REC CAMPUS EXPANSION
PICKLEBALL COURT
 2686 S GOLIAD ST (SH 205)
 ROCKWALL, TX 75032

SP2024-046: Site Plan for 2686 S. Goliad Street

PROJECT NUMBER: SP2024-046
PROJECT NAME: Site Plan for 2686 S. Goliad Street
SITE ADDRESS/LOCATIONS: 2686 S GOLIAD ST

CASE CAPTION: Discuss and consider a request by Frank Polma, PE of R-Delta Engineers, Inc. on behalf of Stephen Geiger Rayburn County Electric Cooperative for the approval of a Site Plan for Private Recreation Facilities on a 1.57-acre parcel of land identified as Lot 1, Block A, Estep Subdivision, City of Rockwall, Rockwall County, Texas, zoned Planned Development District 44 (PD-44) for Commercial (C) District land uses, situated within the SH-205 Overlay (SH-205 OV) District, addressed as 2686 S. Goliad Street [SH-205], and take any action necessary.

1 NORTH ELEVATION
SCALE: 3/16" = 1'-0"

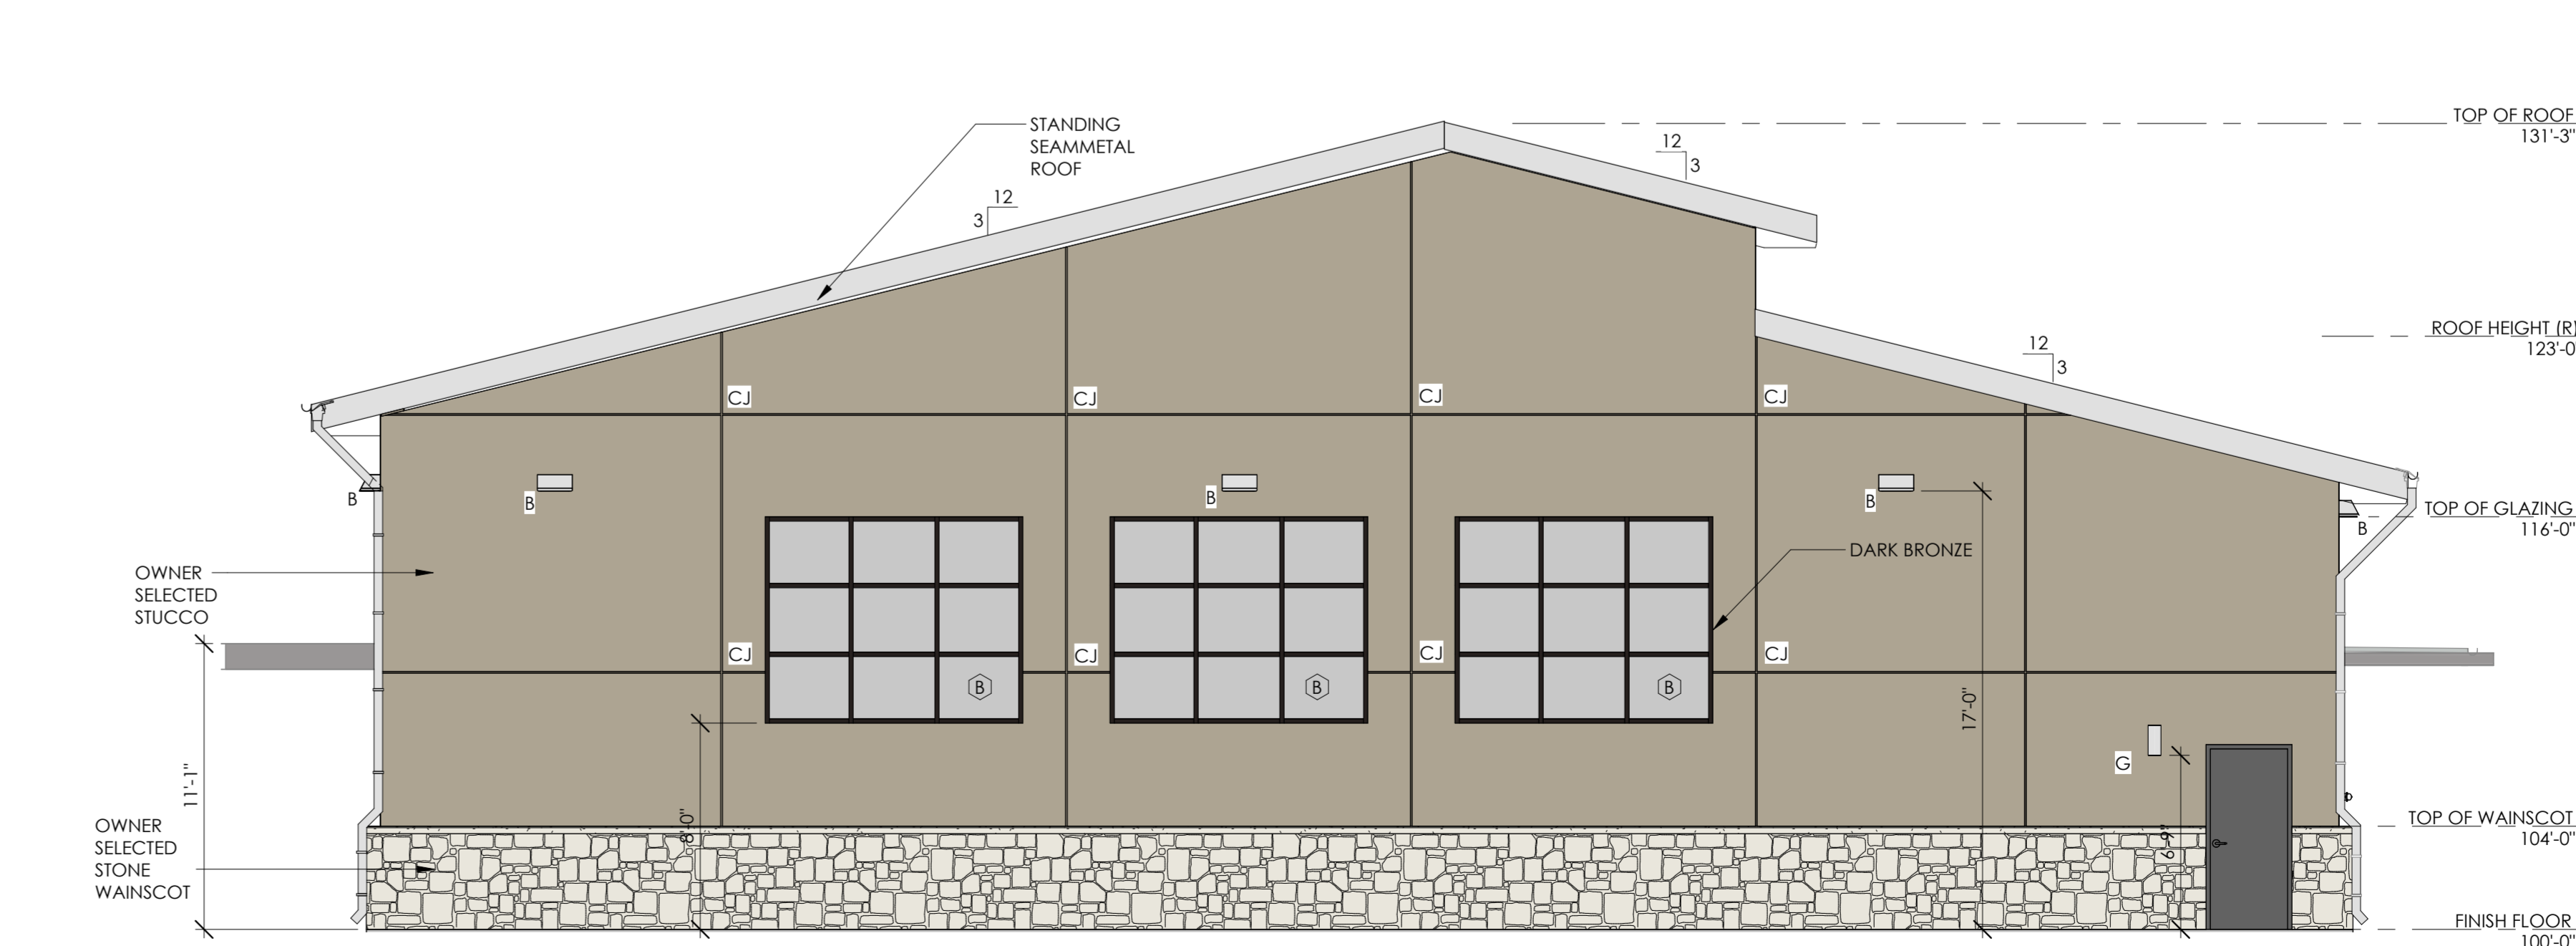
- (5) Please clarify if there will be any RTUs. If so, they must be crosshatched on the building elevations. (Subsection 01.05. C, of Article 05, UDC)
- (6) Provide a note that there will be no outside storage or above ground storage tanks. (Subsection 01.05. D, of Article 05, UDC)

- (1) Please update the table indicating the percentage surface area for each of the proposed materials. This should not include the roof. This will change the material percentages for the stone and stucco. Based on this, the stone may be over the 20% stone requirements (Subsection 04.01, of Article 05, UDC)

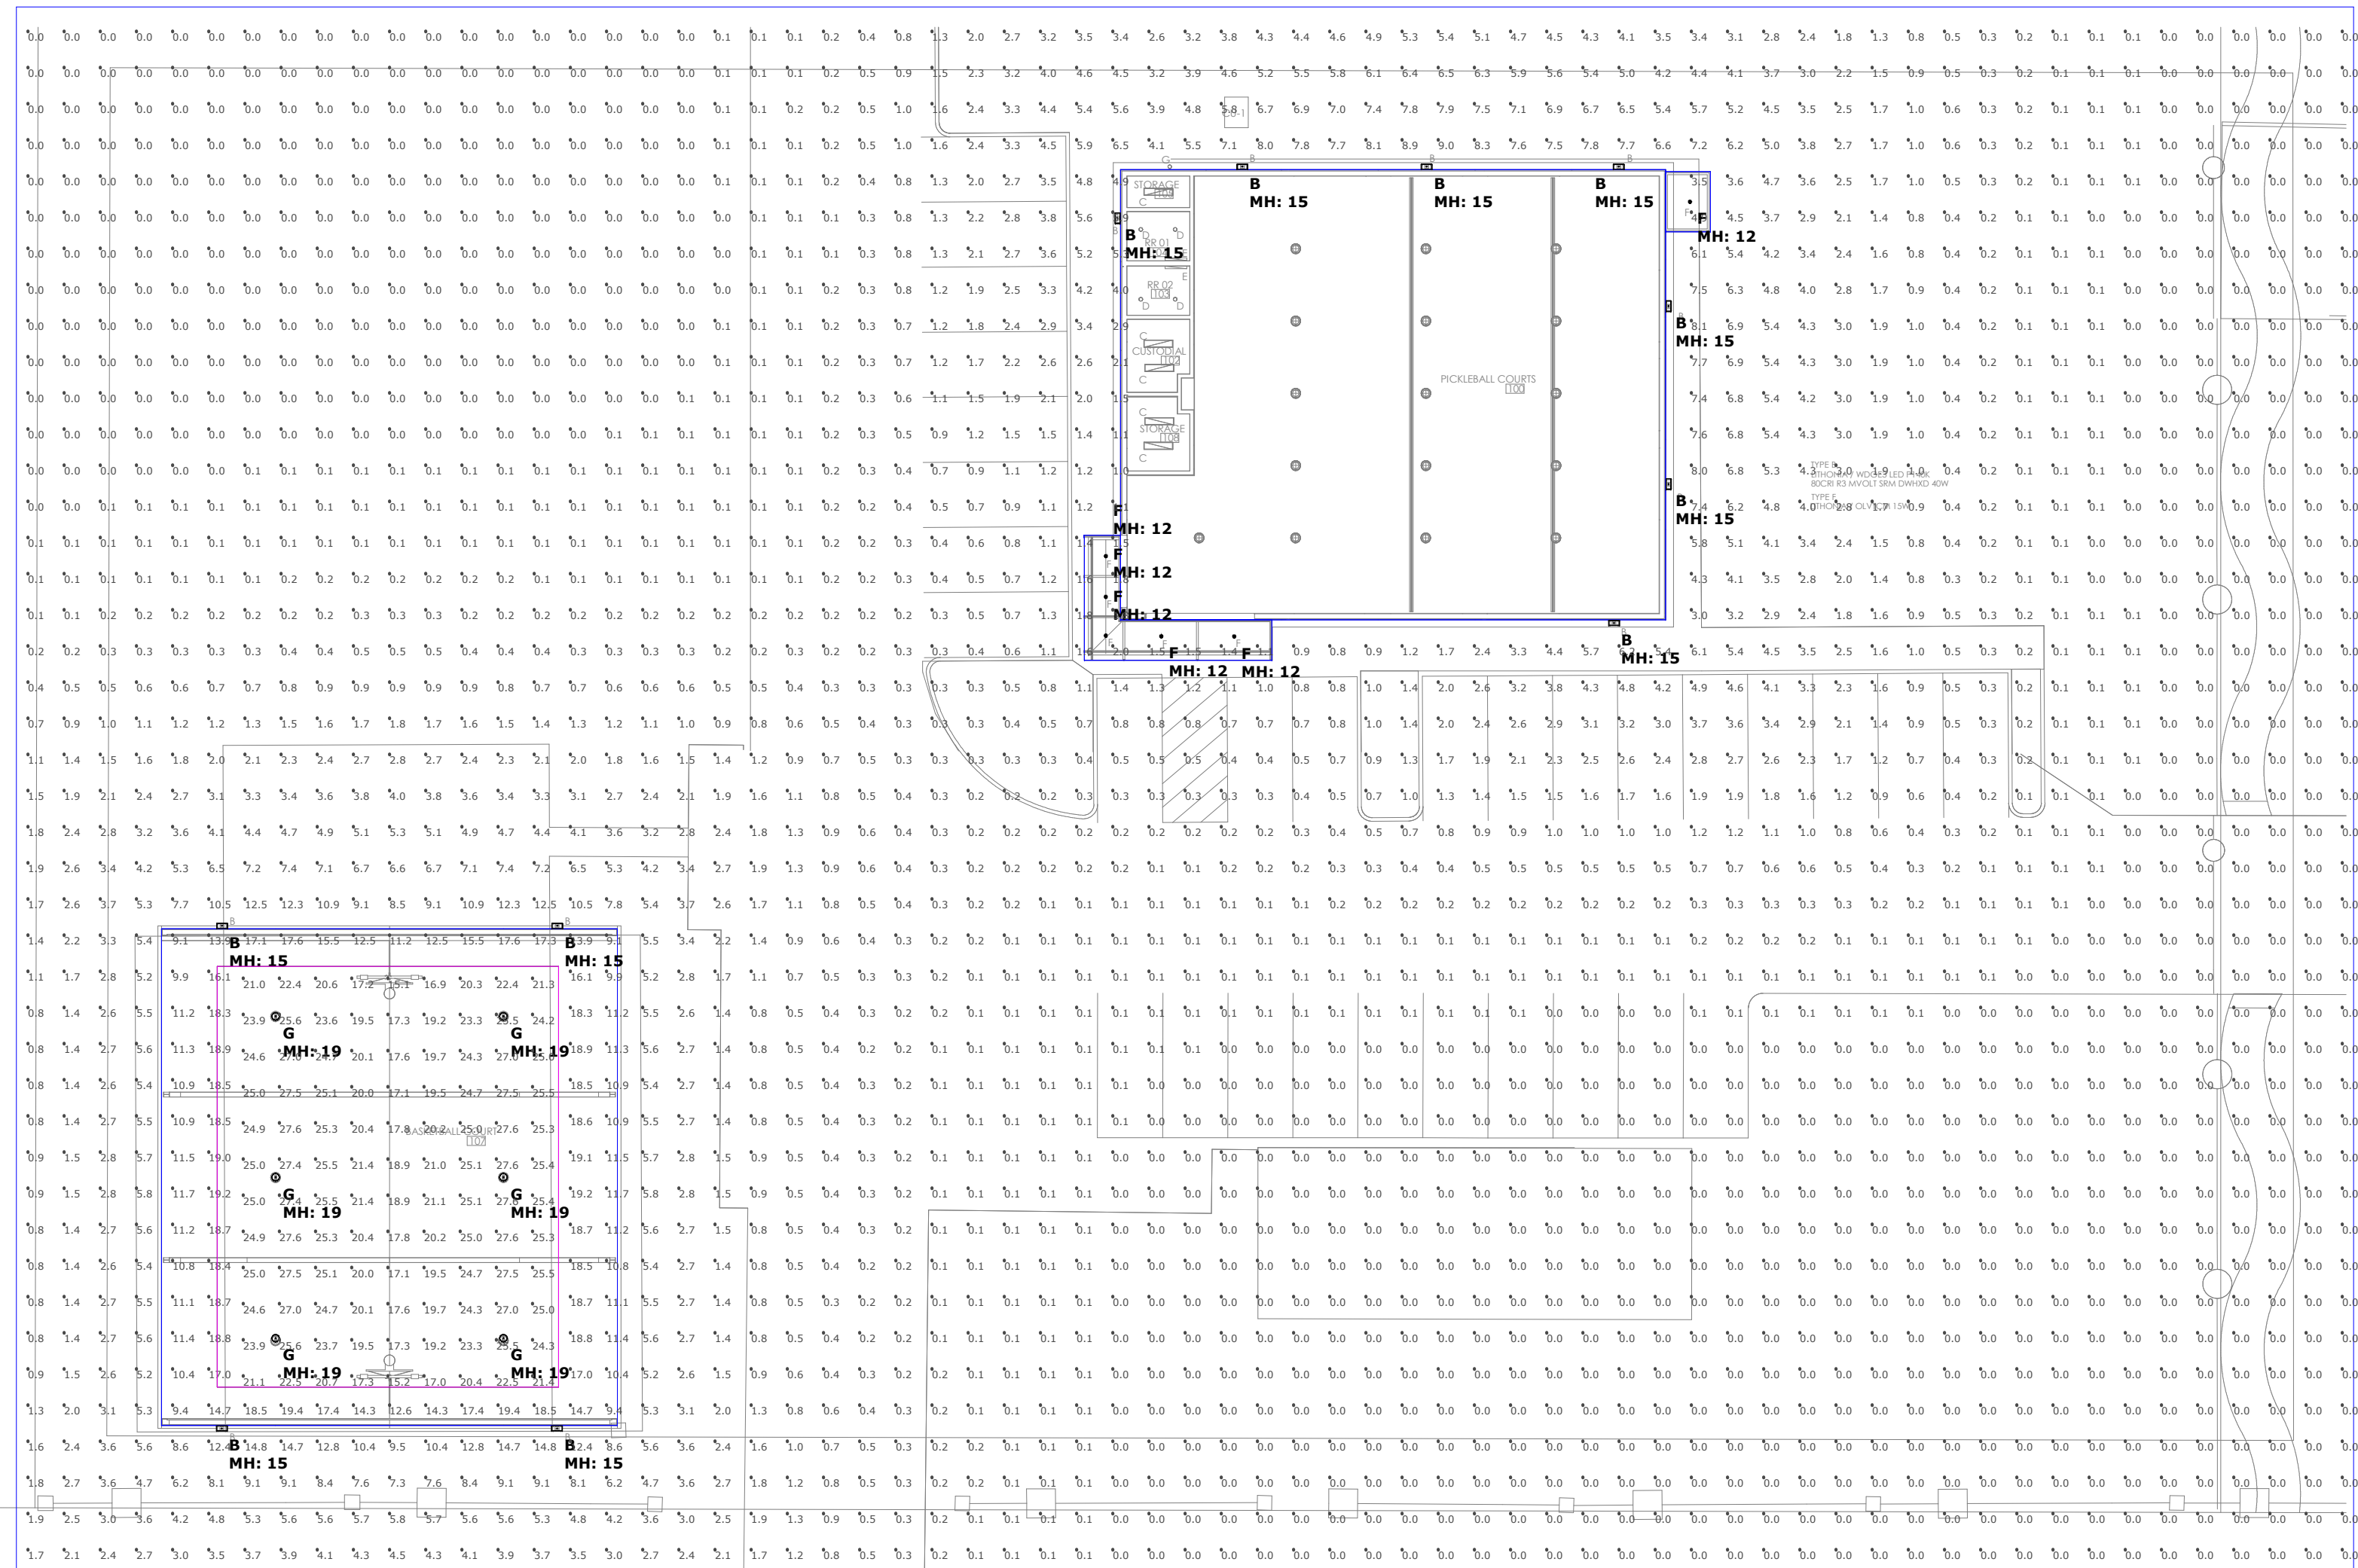
M.8 Photometric Plan

- (1) Provide the same site data information required in Section 2.1 Site Plan: Miscellaneous and Density and Dimensional Requirements of this checklist. (See Sec. 2.1 of the checklist)
- (2) Please note that up lighting is not permitted. (Subsection 03.03, of Article 07, UDC)
- (3) The light levels may not exceed 0.2 FC at any property line where new light fixtures are proposed. Currently the lighting on the new building exceeds this requirement. If none of the lighting is being replaced for the basketball court then this does not need to be included on the photometric plan. If this lighting is being replaced, it must meet the 0.2 FC requirement. (Subsection 03.03.G, of Article 07, UDC)
- (4) Please provide lighting cut sheets for all proposed fixtures. (Subsection 03.03, of Article 07, UDC)

CASE #
CITY SITE PLAN SUBMITTAL

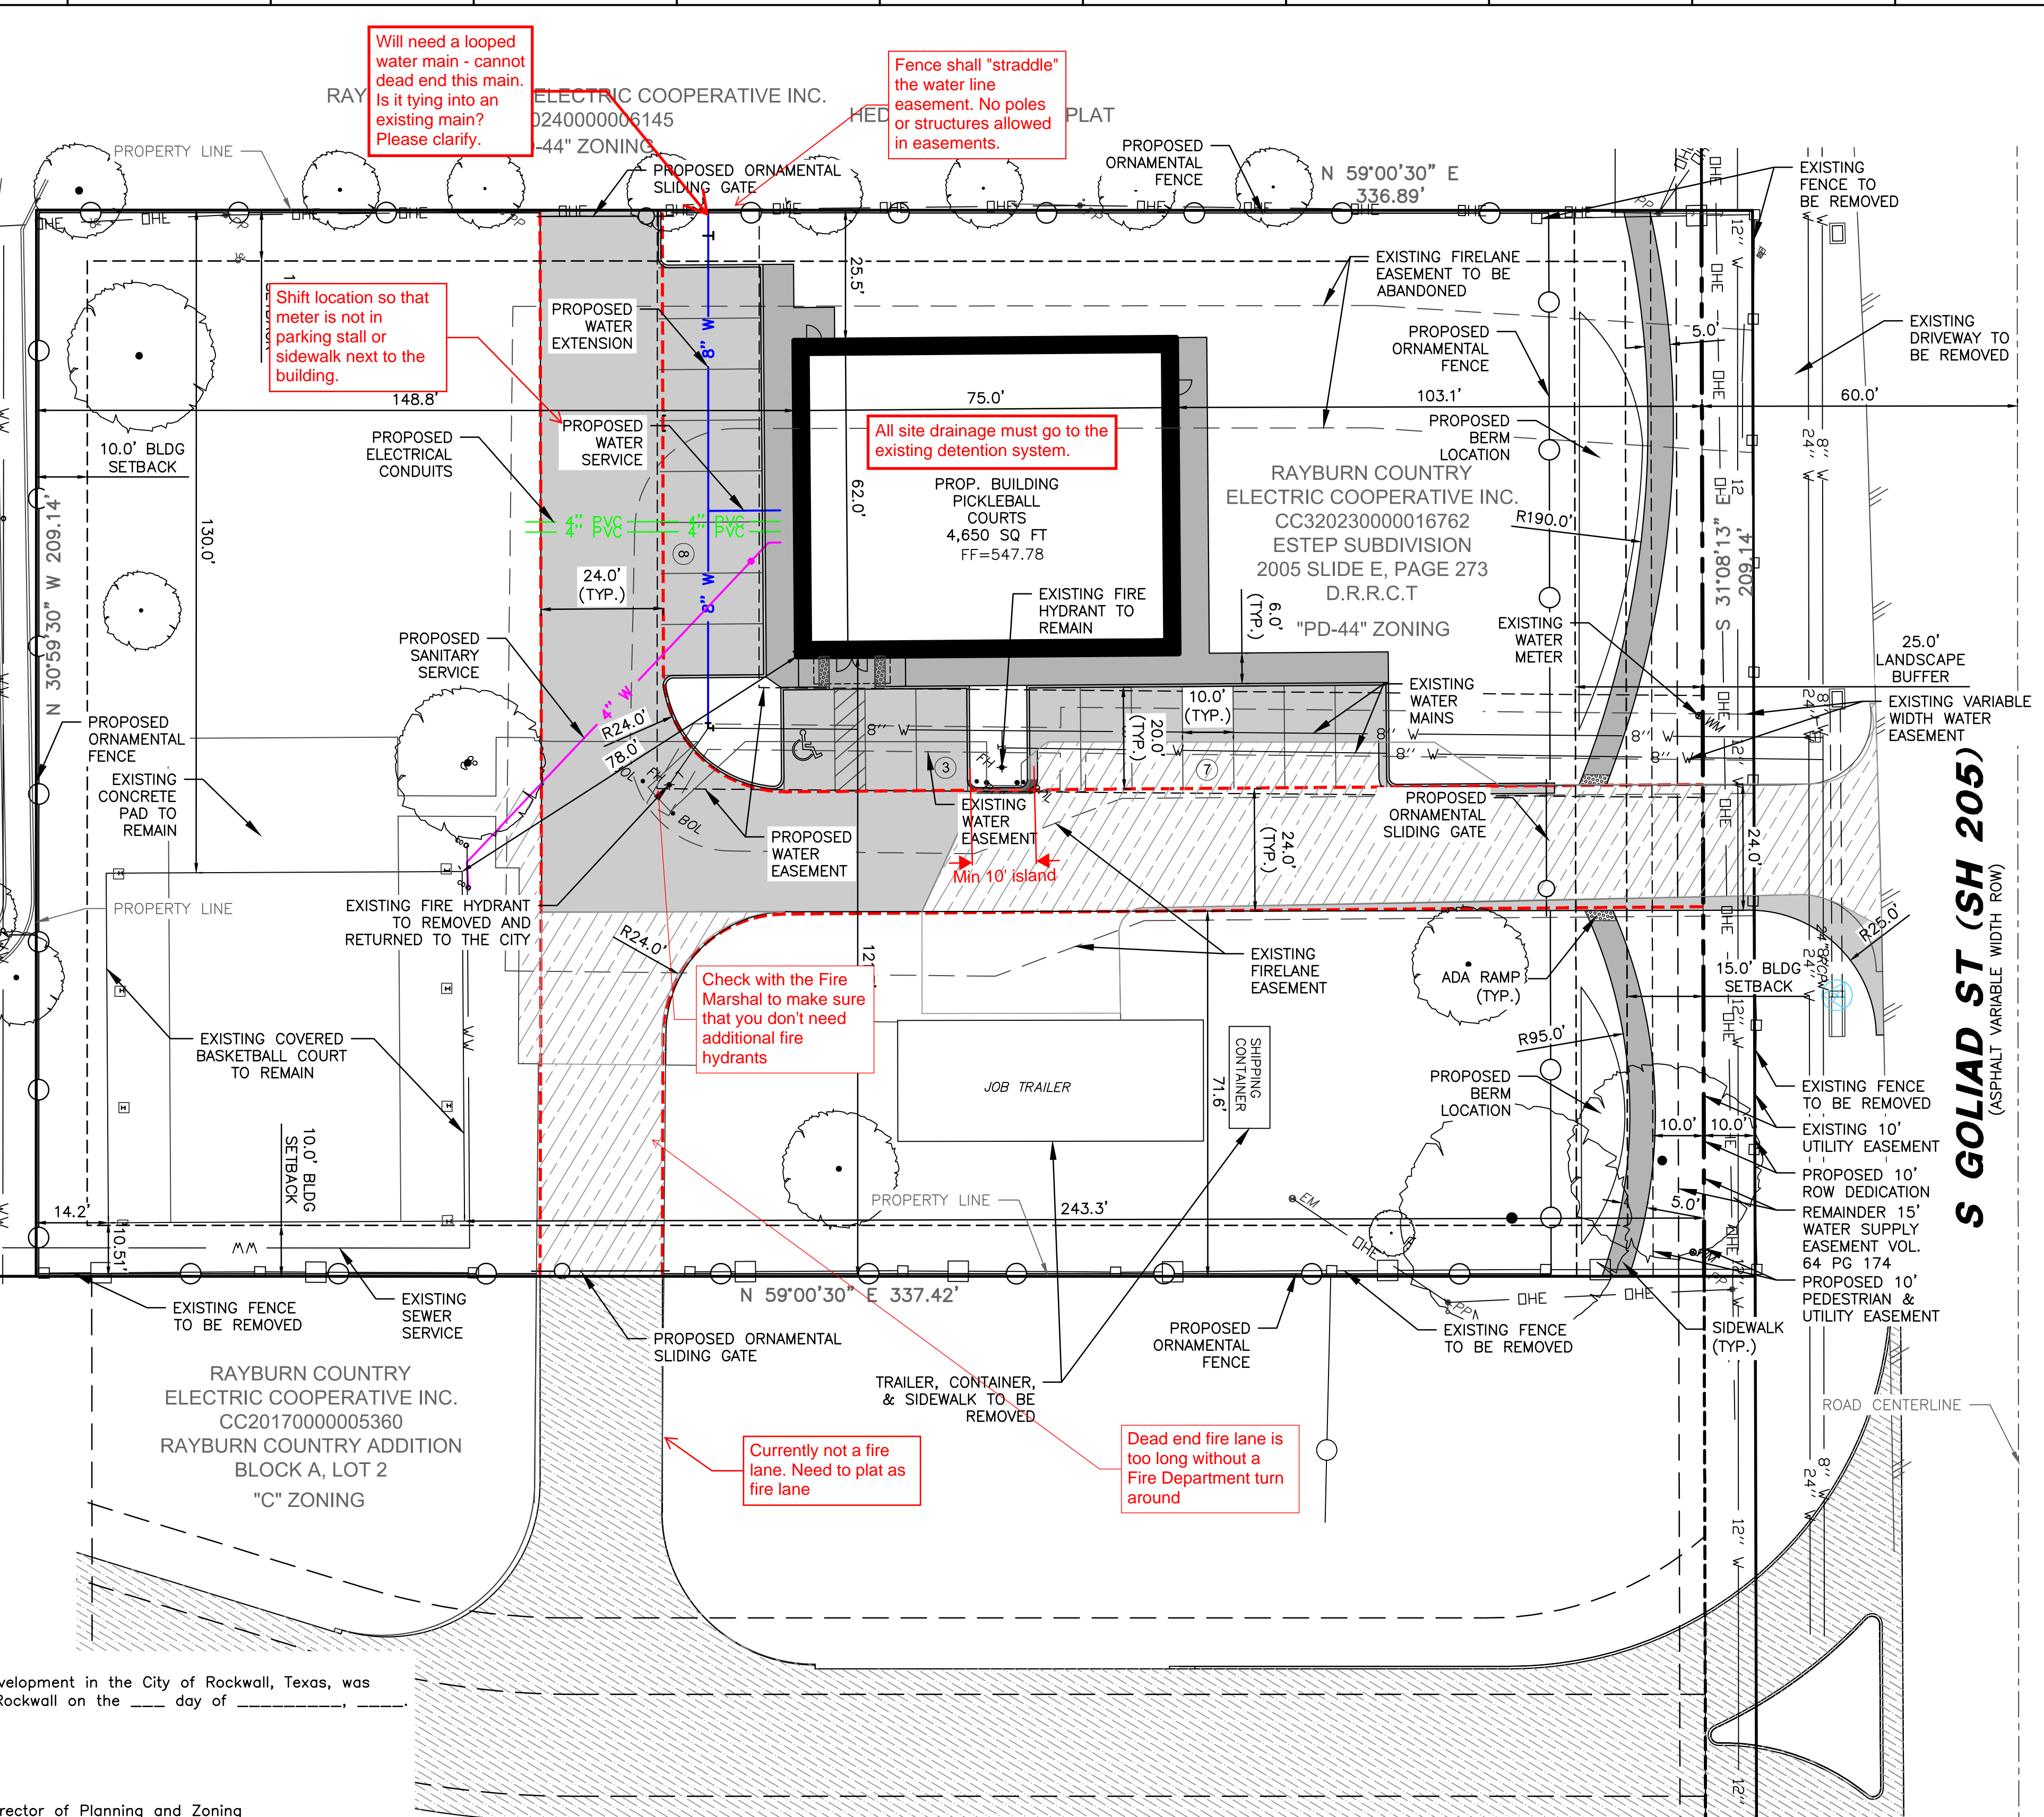
Will need a looped water main - cannot dead end this main. Is it tying into an existing main? Please clarify.
